warehouse / office Bld.
Gringolet Assoc.

**CITY OF PORTLAND, MAINE
DEVELOPMENT REVIEW APPLICATION
PLANNING DEPARTMENT PROCESSING FORM
Planning Copy**

Warehouse/Office Building
Project Name/Description

Drawing Name:
EROSION CONTROL & VEGETATION PLAN

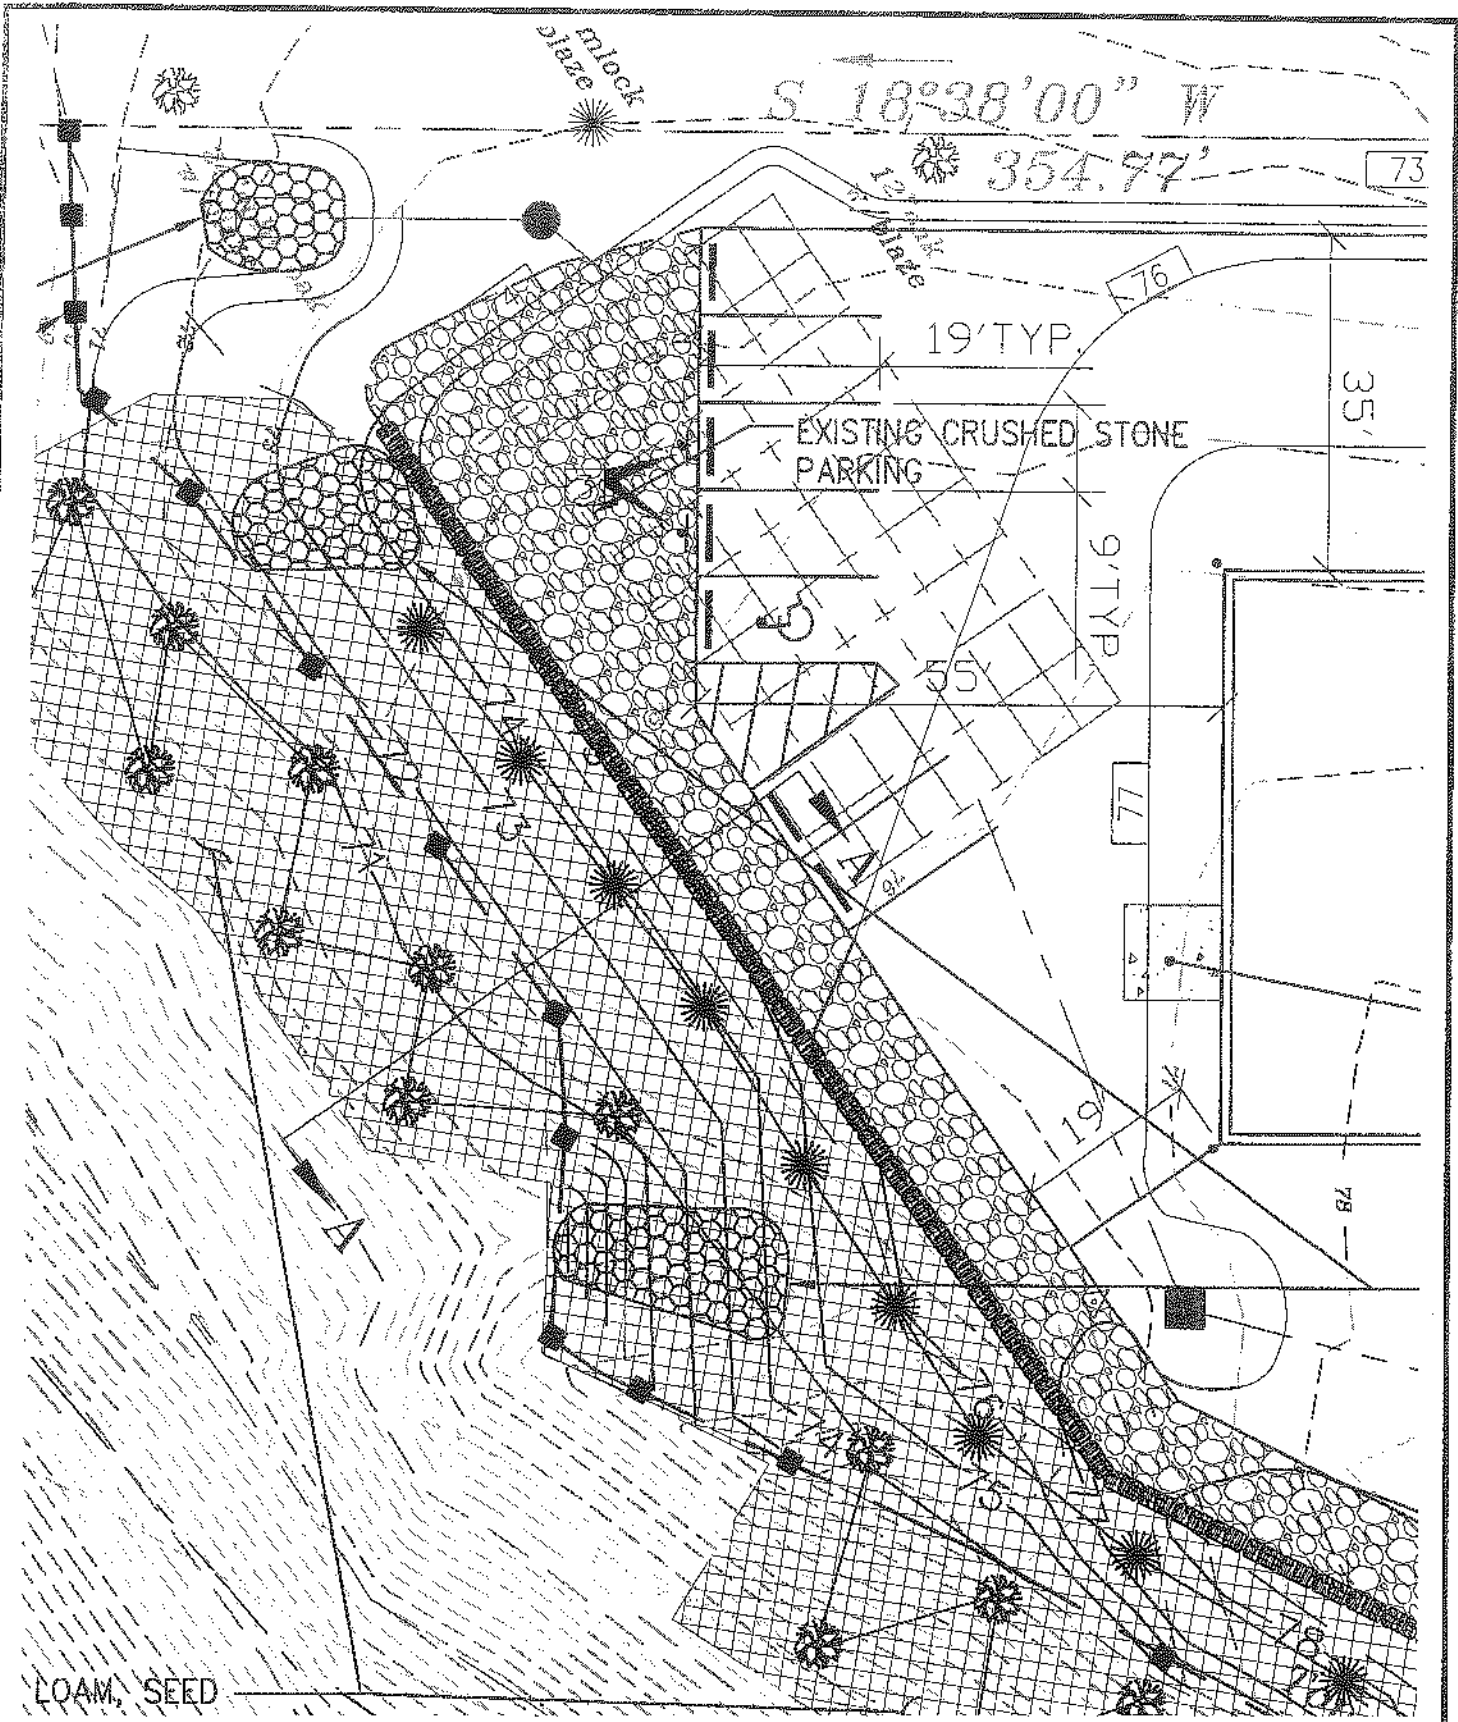
Lets do this, I'll return the PBR all together with the understanding that a full NRPA permit is in the works. I will accept a restoration plan w/o a permit application that shows the entire area being revegetated, including the area with the stone.

I need to accept a restoration plan before I can have you (Josh) do anything out there, you want to get things moving along and I want the slope stabilized before winter. Let us start there, we can keep the restoration and any permit separate.

If the full Permit is approved then the rocks can stay at the top and be used as parking, if the application is denied, withdrawn or not submitted then the Department will hold you (Josh) to the restoration plan. Sound fair?

The attached plan shows how the applicant proposes to mitigate the work that has previously been done without a permit. The top of the slope will be rounded out to create more of a moderate slope rather than a steep drop off from the top of bank. The crushed stone now in place actually dissipates the runoff and slows it to deter from further erosion.

Additionally, haybales will be staked along the top of the bank until the vegetation and trees have stabilized the embankment. A wearing course or final paving will be added which will allow the runoff that currently drains past the catch basin to enter the basin and be transported to the subsurface detention facility on the site. This will mitigate the major area of erosion where the runoff was creating a large rill in the embankment. The crushed stone also help to stabilize this area.
